**TOWN OF ERIE**  
**PLANNING COMMISSION AGENDA ITEM**  
**Meeting Date: February 15, 2017**

|                     | A Sketch Plan Review of Parkdale (Erie Gateway South)                                                                                                                                                                                                                                             |

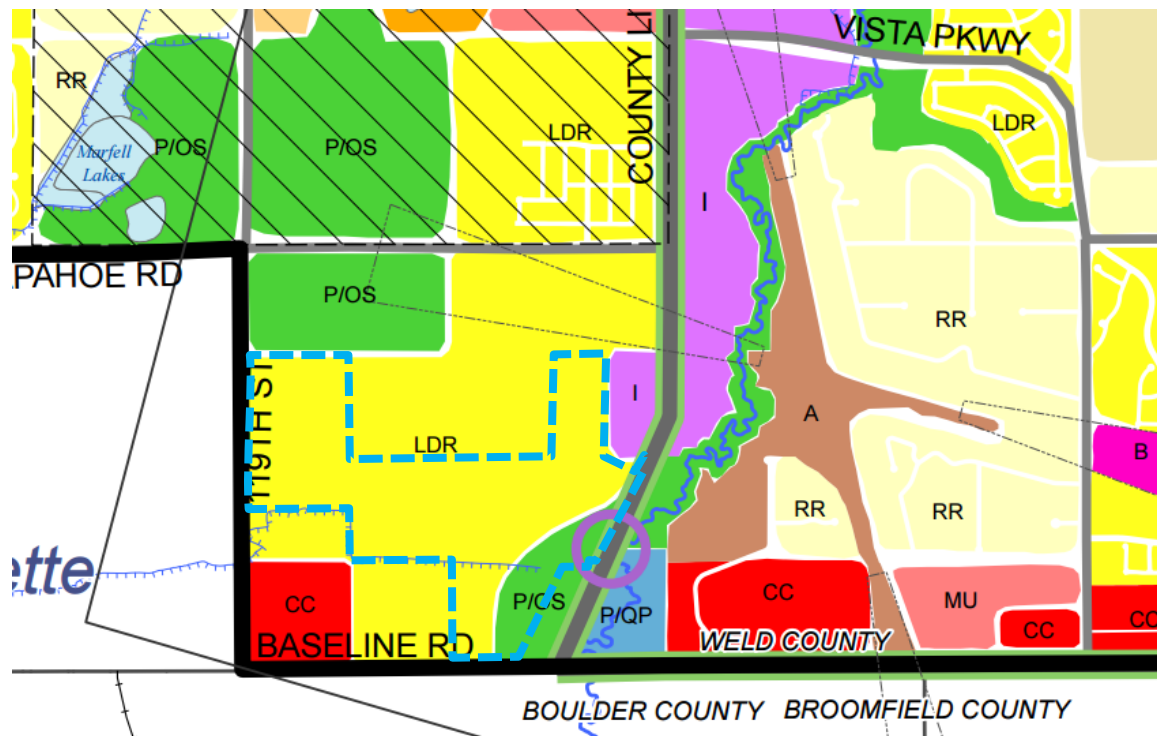
The Sketch Plan application proposes a new gateway into the Town of Erie through construction of a new entrance from State Highway 7, a realignment of County Line Road as a landscaped parkway, and the development of residential units and landscape areas on both sides of this new north-south arterial. A collector road heading east from the arterial provides access to the Messersmith-Boehle Open Space properties along Coal Creek and the original County Line Road alignment. A single access point into the subdivision is located off N. 119<sup>th</sup> Street. The

plan also provides for several road stubs into adjacent properties that could be developed in the future.

The development incorporates multiple single-family detached lot types described by the applicant as ranging from larger Manor Home and Country Home lots down to Village Home and Patio Home lots. Alley-loaded Paired Homes, mostly facing interior common green spaces, are proposed in the northeast portion of the subdivision adjacent to Tri-County Storage.

Wetlands exist at the southeast corner of the site, and the applicant is preserving the wetlands as dedicated open space. This open space area is in compliance with the Town's Comprehensive Plan Land Use Plan Map which designates the wetlands as Parks/Public Open Space. An east-west Spine Trail alignment is proposed from the Great Bark Dog Park on N. 119<sup>th</sup> Street in Lafayette east through an open space corridor, through an underpass beneath the new County Line Road alignment, along the north edge of the wetlands, across the old County Line Road alignment, and connects into the existing Coal Creek Trail.

- *Neighborhood Park*: The development generates a requirement for 5.57 acres of Neighborhood Park. As this acreage falls short of the minimum 7 acre Neighborhood Park requirement, the developer will be required to make payment of the Neighborhood Park Land and Development Construction Cost Fee at Final Plan.

- *Pocket Park*: A total of 0.93 acres of pocket park are required. Based on the layout of the subdivision and compliance with the UDC's location requirements, at least four pocket parks, as shown in the Sketch Plan, are required and would exceed the 0.93 acre requirement.

- *Open Space*: The open space dedication requirement at Parkdale's proposed unit count is 31.59 acres. The Sketch Plan represents an open space dedication in the amount of 40.92 acres. Further analysis shall occur during Preliminary Plat to insure that all public open space areas identified for dedication are eligible for credit.
